RE: Way Point Block 1002 Lot 7

**RE: Block 1002 Lot 7
Summit Avenue**

The plans dated 6/26/20 were reviewed by the Montvale Fire Department plan review committee and have the following comments and concerns.

Turning Performance Analysis

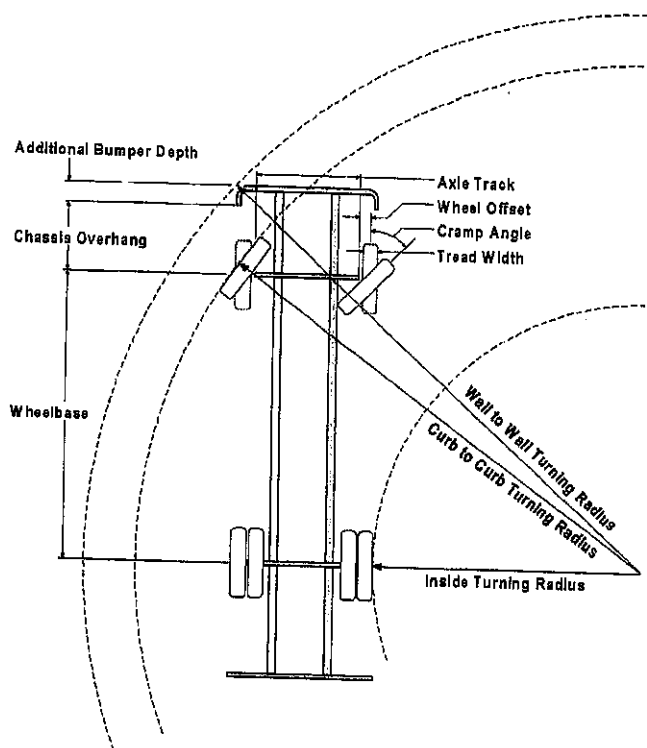
- Fire access to the building is better than the previous revision, but the fire department would still prefer access completely around structure. The fire lane must be maintained 24/7 including full snow plowing and no parking allowed. The Fire lane must be marked with no parking fire lane. As shown, a fire truck or any large truck pulling in to the east side of the building, would have to back out all the way to Summit Avenue. We are also unsure if Engine M-1 and Tower Ladder M-5 would be able to make the left turn to access the south and west side of the building. Enclosed is copy of turning performance for M-5.

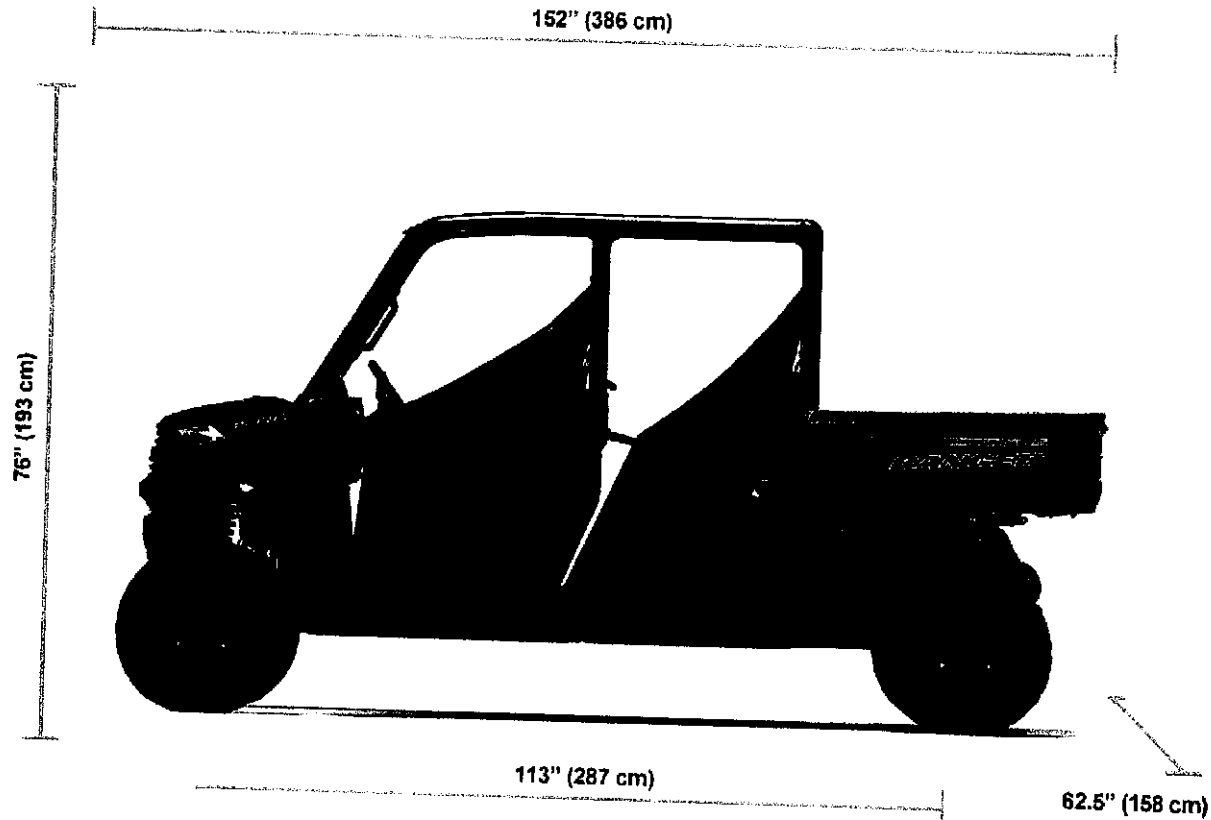
- The fire department is requesting a copy of any flow tests that were performed by Suez.
- Knox Box installed (location to be determined by the fire department)
- Separate standpipe 5" Stortz connections for garage and structure and both to be located near the hydrant by front door.
- Remove access island at Summit Ave or make a mountable curb
- Clarification of driveway elevation change (fire apparatus angle of attack and departure)
- The bridges on the walking trail should be wide enough and be able to handle the weight of a fully loaded Polaris 1000 UTV.(3500 LBs)
